MODERNIZATION AT CURRAN MIDDLE SCHOOL FOR:

MARK	DATE	DESCRIPTION
SD		
CD		
01	08/23/07	ADDENDUM 1
02	09/11/07	ADDENDUM 2
03	11/01/07	ADDENDUM 3

SHEET TITLE
PARTIAL FLOOR PLAN
BUILDING E

SHEET IDENTIFICATION NUMBER
A-423
SHEET 38 OF 46

A4 PARTIAL FLOOR PLAN BUILDING 'E'
1/8"=1'-0"

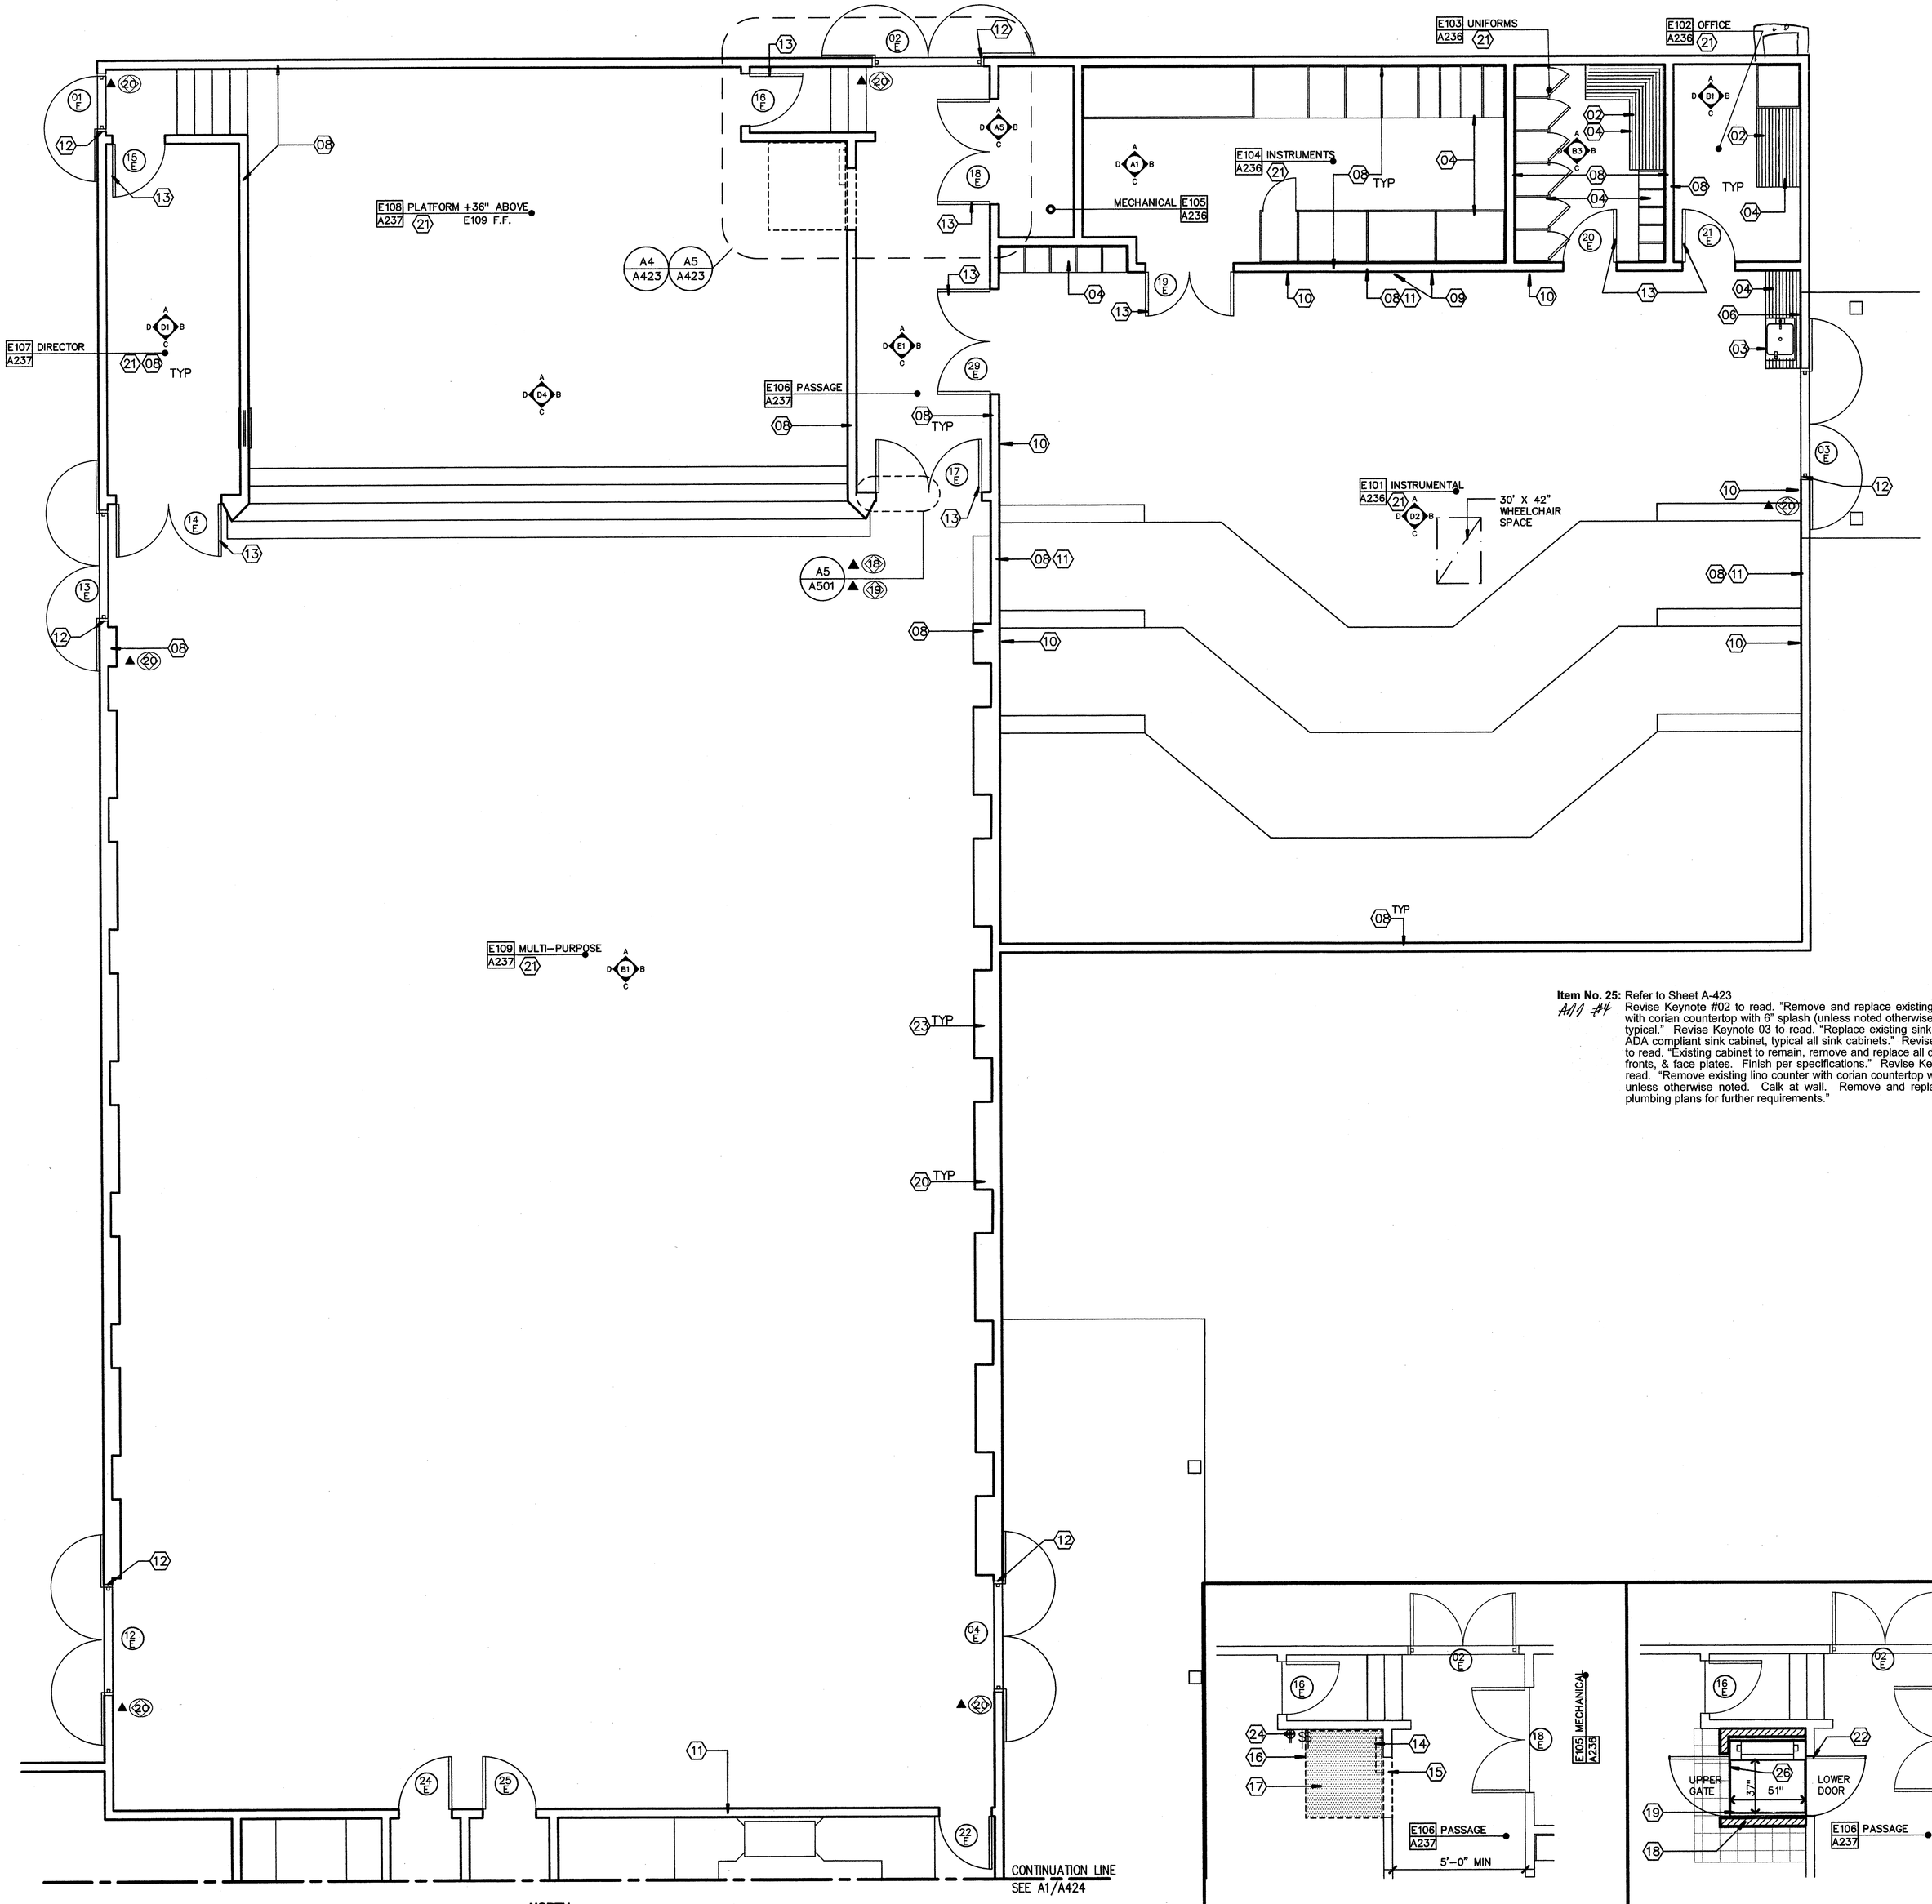
Item No. 25: Refer to Sheet A-423
Add #4 Revise Keynote #02 to read. "Remove and replace existing counter top with corian countertop with 6" splash (unless noted otherwise) calk to wall typical." Revise Keynote 03 to read. "Replace existing sink cabinet with ADA compliant sink cabinet, typical all sink cabinets." Revise Keynote #4 to read. "Existing cabinet to remain, remove and replace all doors, drawer fronts, & face plates. Finish per specifications." Revise Keynote #05 to read. "Remove existing lino counter with corian countertop with 6" splash unless otherwise noted. Calk at wall. Remove and replace sink see plumbing plans for further requirements."

02 REMOVE/REPLACE (E) LINO COUNTER (OR PLASTIC LAMINATE COUNTER WH/OCCURS) W/CORIAN COUNTERTOP W/6" SPLASH (UNO), CAULK @ WALL.

03 REPLACE EXISTING SINK CABINET WITH ADA COMPLIANT SINK CABINET TYPICAL ALL SINK CABINETS
